### **SM300 Exhaust Manifold Adaption**

TSB-16-001

Date: December 5, 2016 Model: SM300

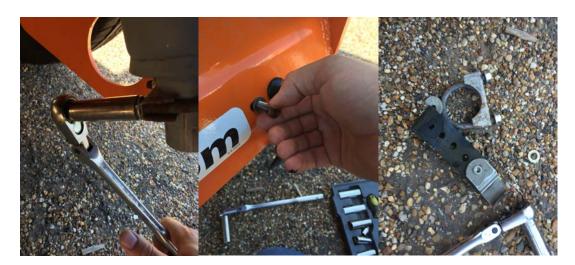
Laymor has determined that some of the sweepers may be subjected to excessive vibrations resulting in exhaust manifold breakage. This TSB will be fix on fail.

1. Start by removing the lower exhaust hanger strap located below the right side of the radiator. Discard strap.

2. Next remove the exhaust down pipe bolts (4 ea.)

3. Remove existing exhaust manifold downpipe and remove muffler. Discard downpipe.

4. Remove the top two right rear motor mount bolts.

5. Attach muffler support bracket onto the right rear motor mount. Apply thread locker to both bolts and torque to 50 Ft. Lbs. using the 17 MM socket.

7. Install muffler to down pipe. Install muffler to assembly to new muffler mount bracket.

8. Install exhaust muffler U-bolt clamp and leave slightly loose. Install muffler down pipe assembly to exhaust manifold. Torque manifold bolts to? Tighten the U-bolt clamp to?
